**City Hall Parking Lot Storm Pipe Replacement
SW2014 - 01**

ADDENDUM NO. 1
To the Contract Provisions for
CITY OF FERNDALE, WASHINGTON

CITY HALL PARKING LOT STORM PIPE REPLACEMENT
SW2014-01

EXHIBIT A

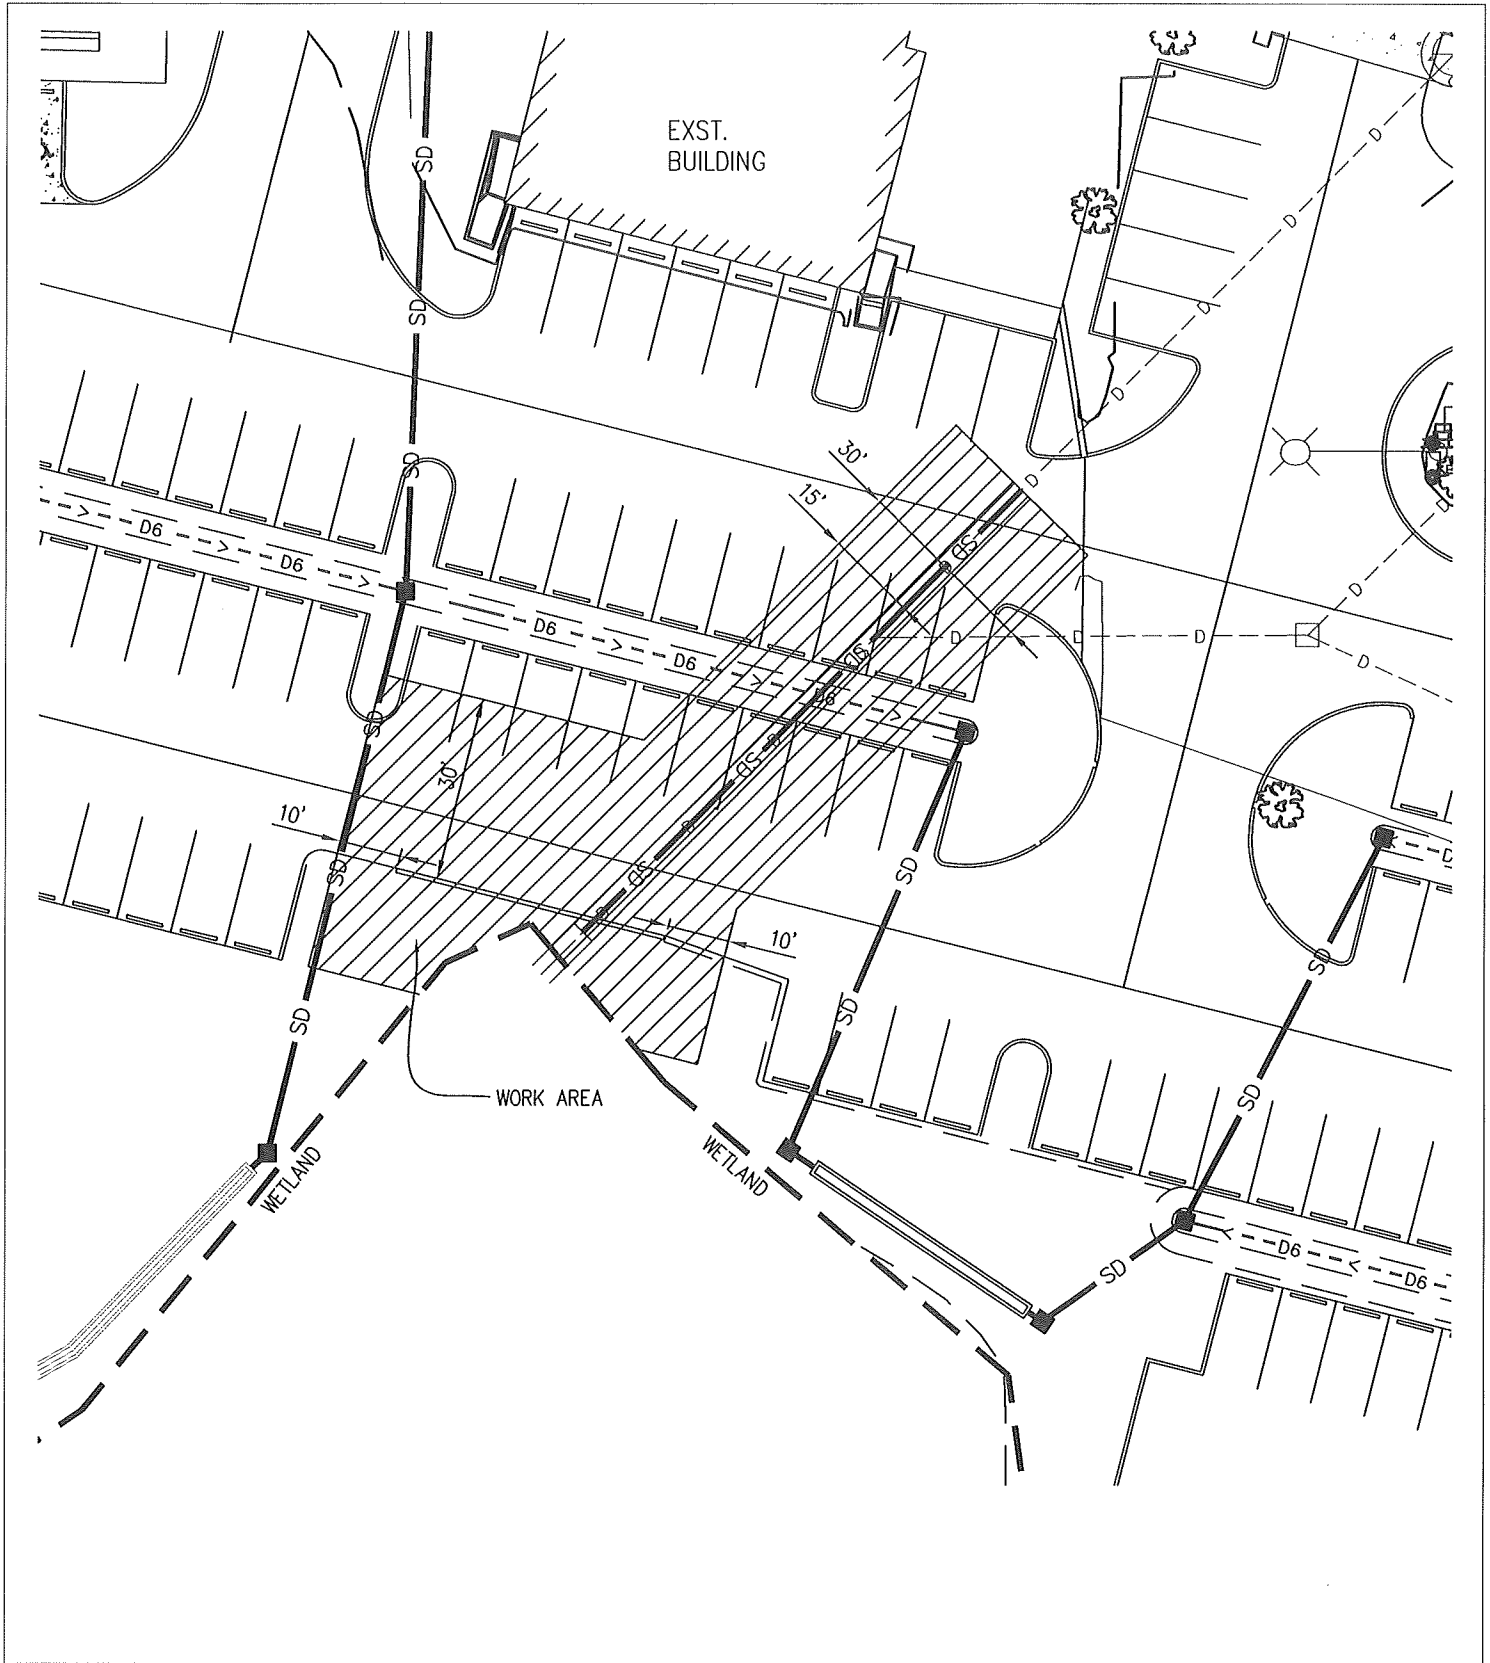
The attached Exhibit A, which shows the "Pipe Replacement Work Area", is added to the Contract Documents.
